TOWN OF BOXFORD

HVAC, Exterior Repairs, Library Renovation
Town Hall/Library
7A Spofford Road
Boxford, MA

ADDENDUM NO. 1 AUGUST 13, 2020

Project No.: 699.1

ELECTRICAL NEW WORK PLANS

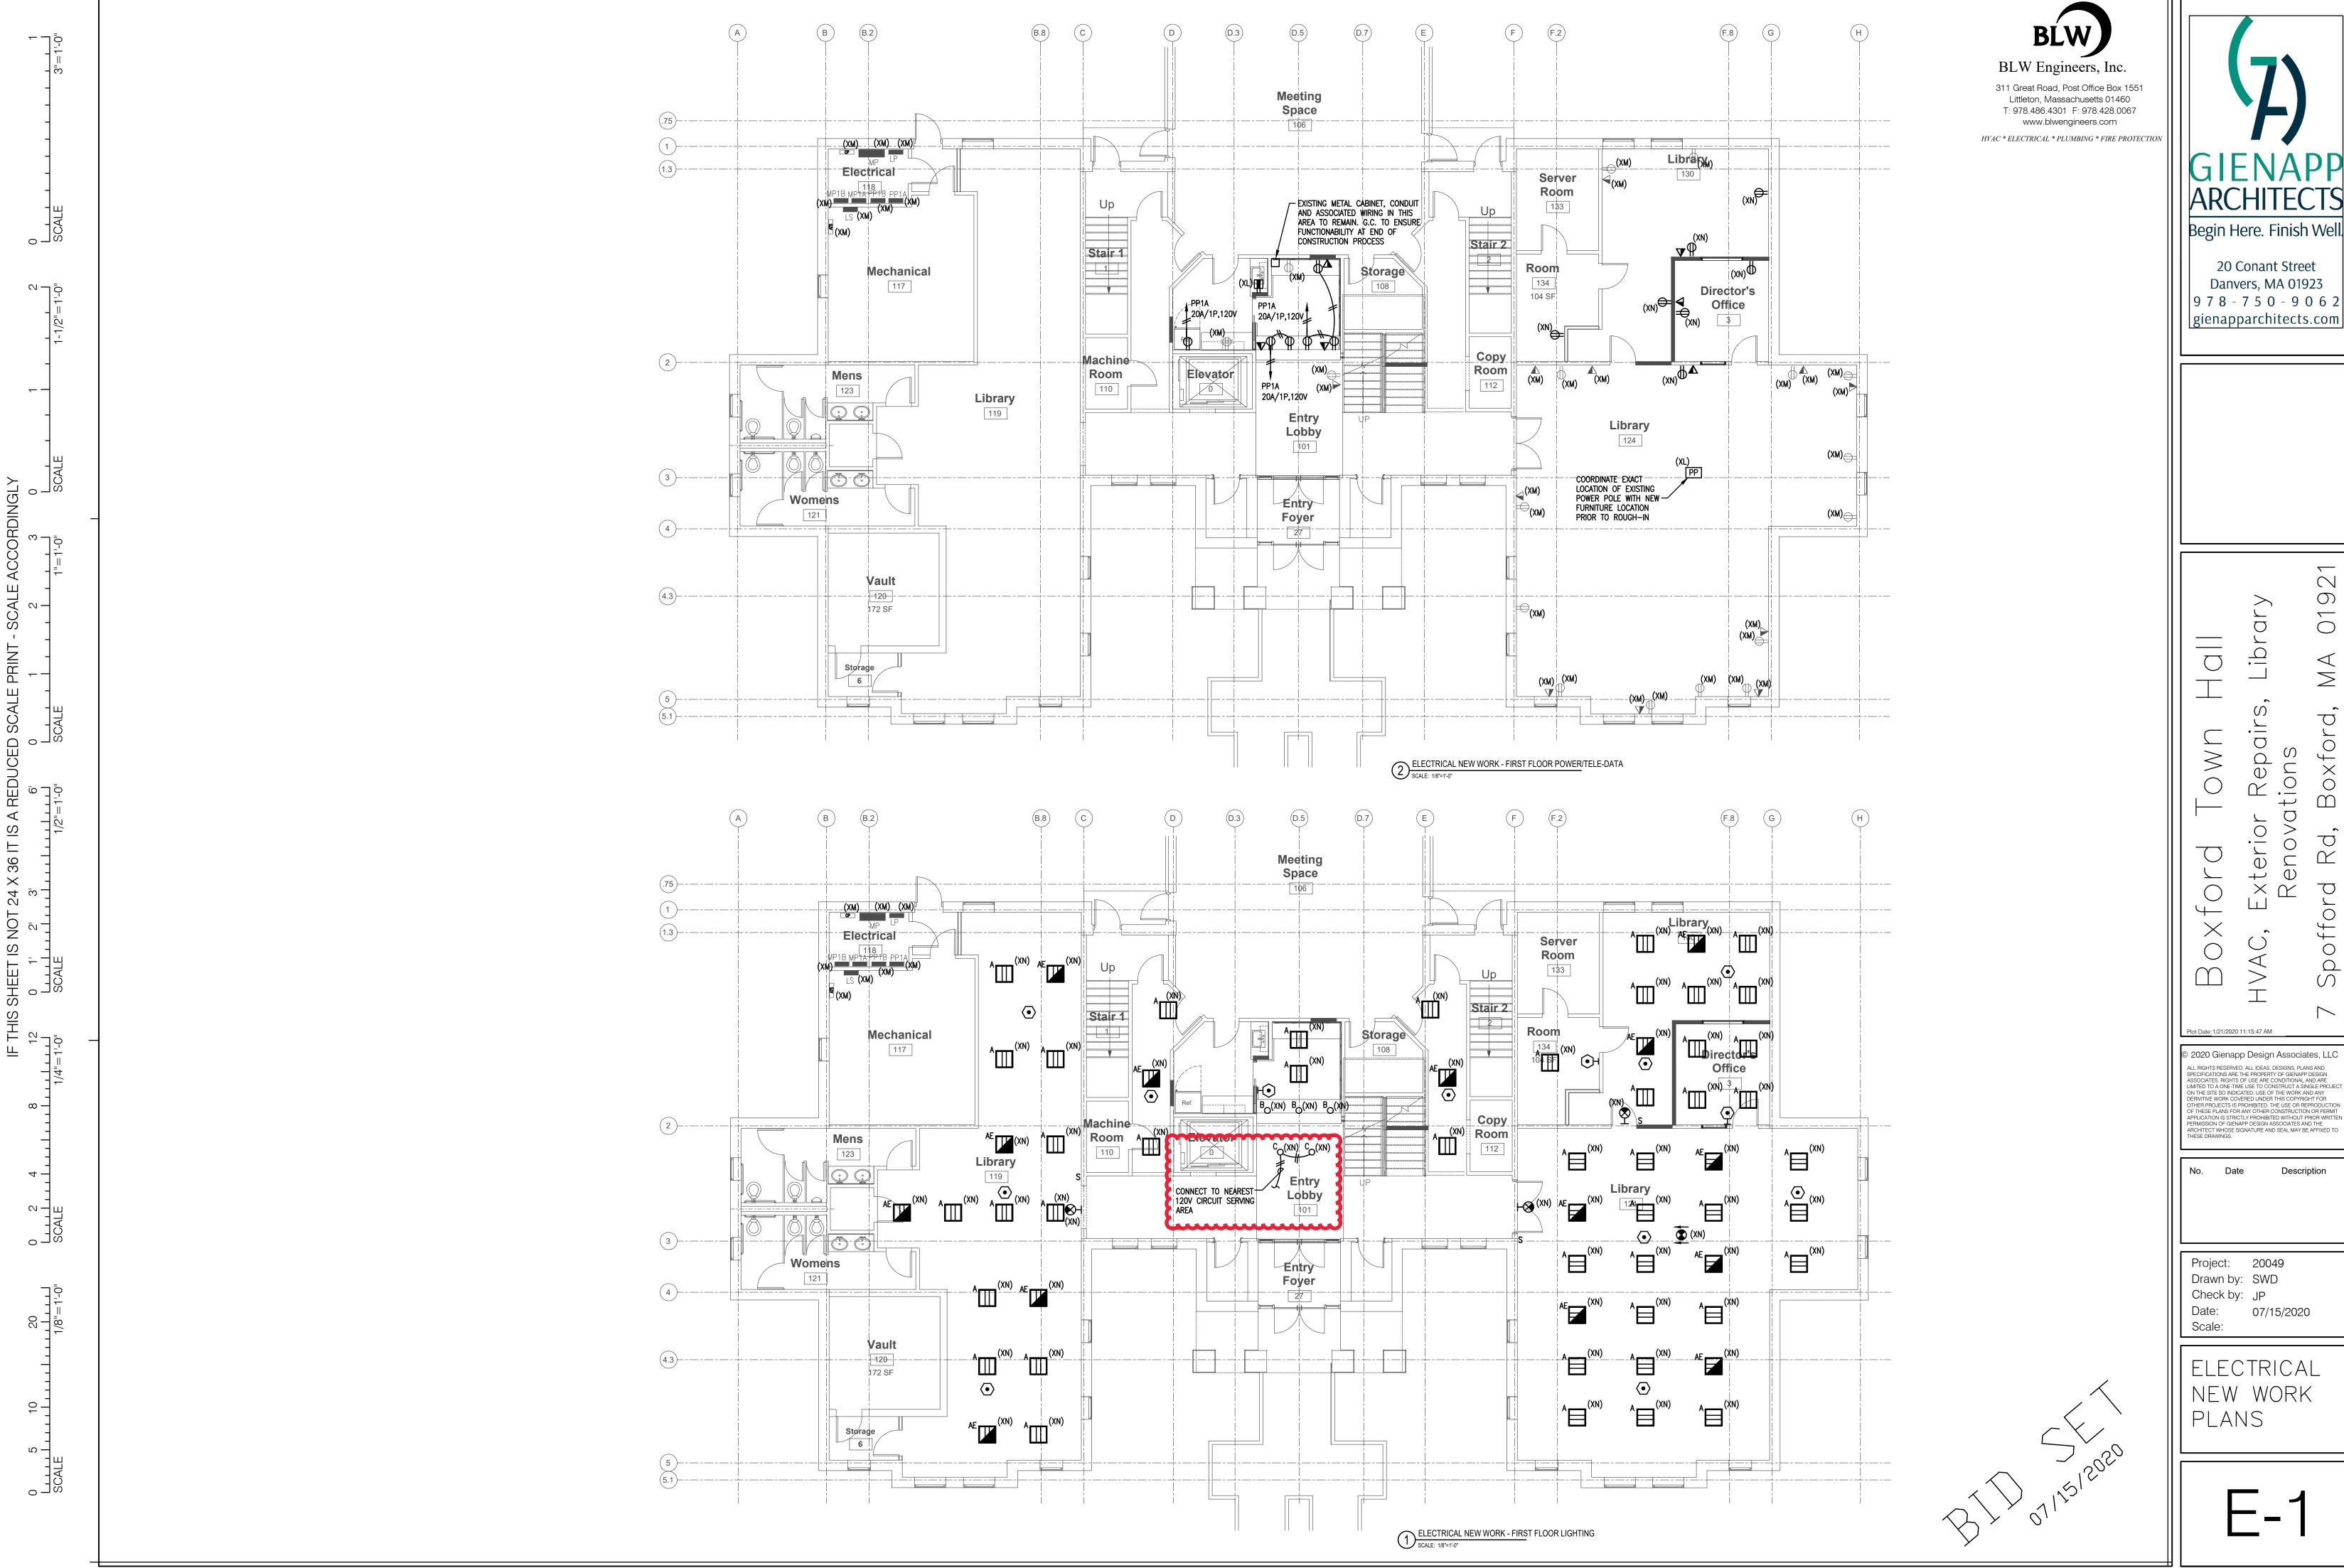
11.1. ADD fixtures in the "Queuing Space" (identified on the plans adjacent to "Entry Lobby") as shown on the enclosed E-1.
